PLANNING APPLICATION PLN-19-0231

11 BURGHLEY STREET, LONGFORD

**RE: Planning Application, 2 Lot Subdivision – 11 Burghley Street, Longford**

# PLAN OF SUBDIVISION

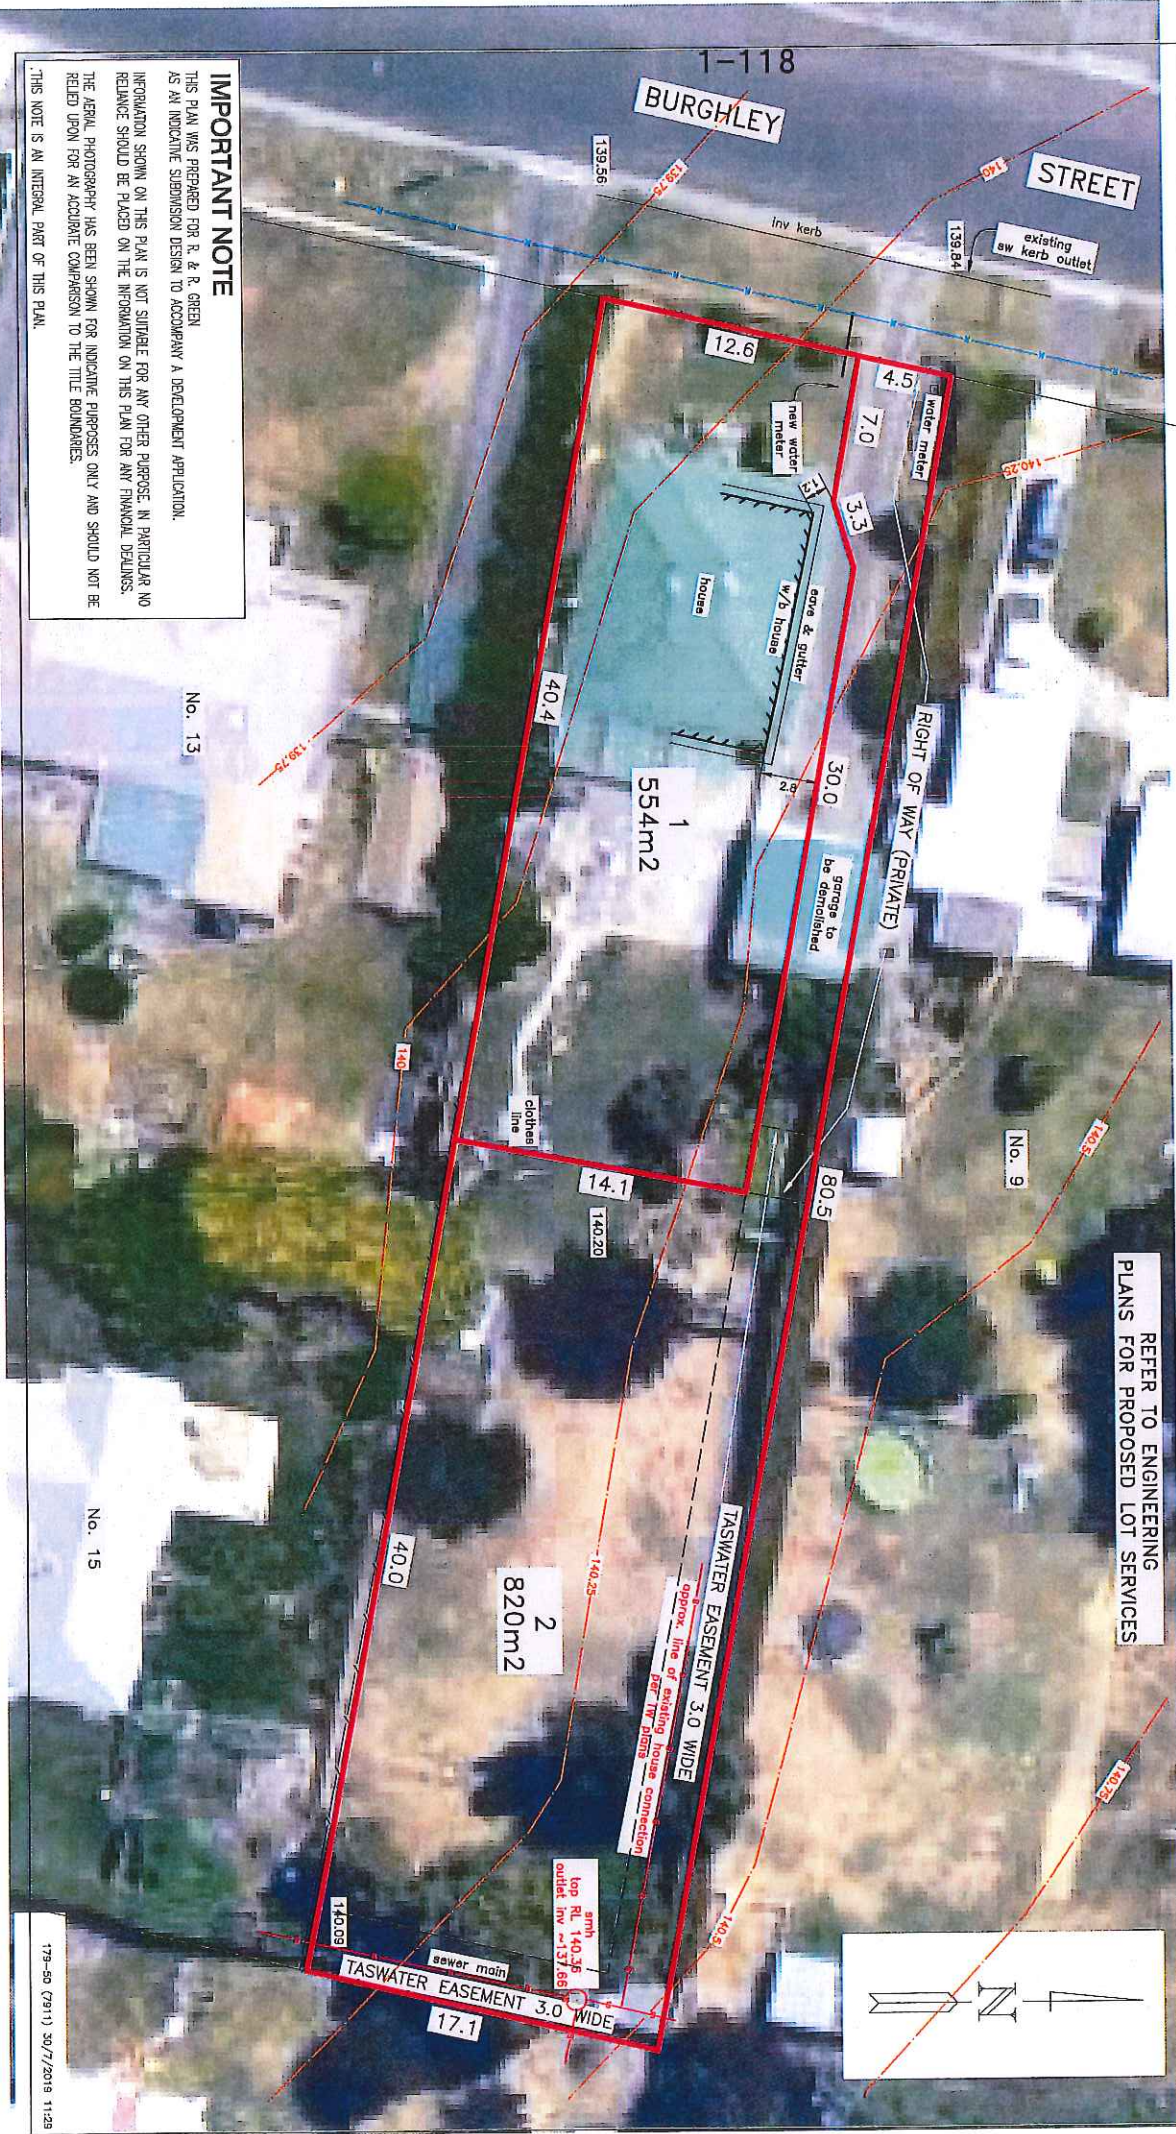
The developer's acknowledge the concerns of the author(s) and agree wholeheartedly of the attractiveness of the Hawthorn Hedge, particularly in relation to privacy, that is located between the subject site and the immediately adjacent property to the north. It is not the intention of the subject application to remove the said Hawthorn Hedge. We further note that the subject site is not heritage listed, nor located within a heritage precinct or a Tourist Road Corridor where such hedgerow may have particular importance within the Planning Scheme. We hope that this confirmation of the intent of this application would enable the author to consider withdrawal of their representation potentially?

We would like to reiterate that the subdivision of the subject site is permitted and the only two discretions sought relate to the variation to access width and a small portion of the driveway being located within attenuation distance, no further discretions are sought by this application. The proposed lot sizes of both lots complies with acceptable solution 10.4.15.1 a) of the *Northern Midlands Interim Planning Scheme 2013* as the lots exceed the required minimum lot size of 450m<sup>2</sup>. It is noted that subclauses a) through to e) of Clause 10.4.15.1 are OR options, whereby the proposal only needs to comply with one of the options to satisfy the requirements. It is noted that subclause e) would typically apply only to adjustment of boundaries where at least two zones apply, which does not apply in this circumstance. The subdivision therefore meets the intent of the General Residential zone noting that the purpose provides for a range of dwelling types at suburban densities and encourages residential development. We wish to further highlight that the author(s) of this representation in fact live on a lot subdivided in 2004, with a similar internal lot arrangement of the proposed development, therefore the proposal is consistent with the character of the area and the zone.

SERVICE PLAN  
SCALE 1:250

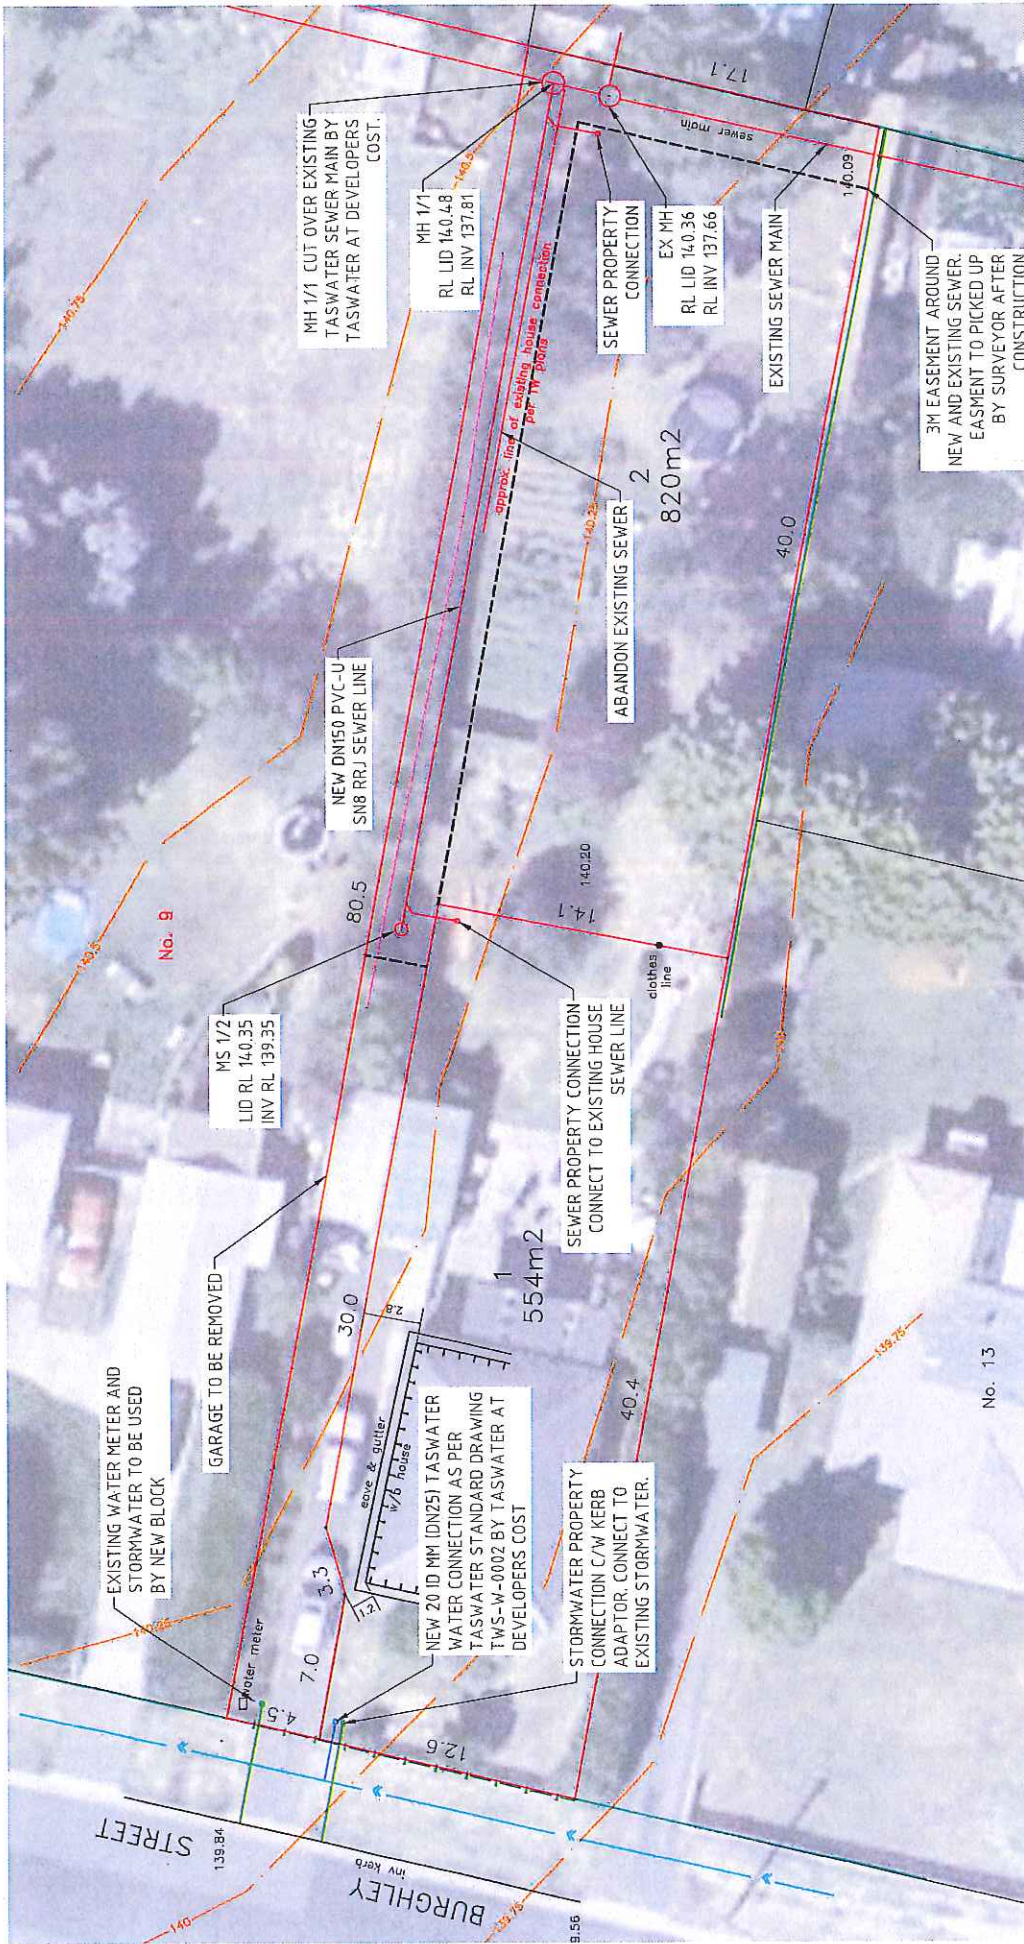
<b>ASSET CREATION &amp; INFRASTRUCTURE WORKS</b>			
<ol style="list-style-type: none"> <li>4. Plans submitted with the application for Engineering Design Approval must, to the satisfaction of TasWater show, all existing, redundant and/or proposed property services and mains.</li> <li>5. Prior to applying for a Permit to construct new infrastructure the developer must obtain from TasWater Engineering Design Approval for new TasWater infrastructure. The application for Engineering Design Approval must include engineering design plans prepared by a suitably qualified person showing the hydraulic servicing requirements for sewerage to TasWater's satisfaction.</li> <li>6. Prior to works commencing, a Permit to Construct must be applied for and issued by TasWater. All infrastructure works must be inspected by TasWater and be to TasWater's satisfaction.</li> <li>7. In addition to any other conditions in this permit, all works must be constructed under the supervision of a suitably qualified person in accordance with TasWater's requirements.</li> <li>8. Prior to the issue of a Consent to Register a Legal Document all additions, extensions, alterations or upgrades to TasWater's water and sewerage infrastructure required to service the development, generally as shown on the concept servicing plan "IPD Consultants Subdivision Plan/1824-003 Sh 3",</li> </ol>

- a) All existing pipes and connections must be located.
- b) Where required, pipes are to be rerouted to provide an independent system for each lot.
- c) Certification must be provided that services have been separated between the lots.
